**PR/0239/22**

## **Record of Executive Business and Chief Executive's Order**

**Reg. Reference:** SD21A/0350      **Application Date:** 21-Dec-2021  
**Submission Type:** New Application      **Registration Date:** 21-Dec-2021

**Proposed Development:** Retention of constructed fence and boundaries and the relocation of existing access gate to revised location and proposed use of space as an allotment.

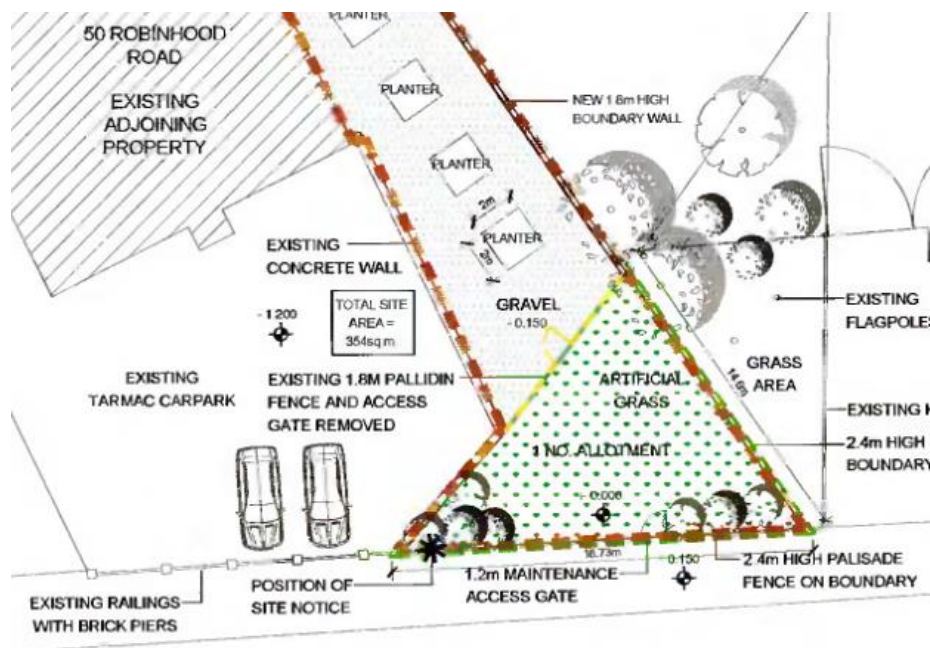
It is noted that in the Site Block Plan and Contextual Elevation drawing submitted it is **proposed** to construction of a new 1.8 m high boundary wall on the eastern side of the subject site. This is not clear in the description of works.

The Site Block Plan and Contextual Elevation drawing submitted also **proposes** the construction of a new 1.8 m high boundary wall on the eastern side of the subject site. Please see extract from drawing below. This is not clear in the description of works.
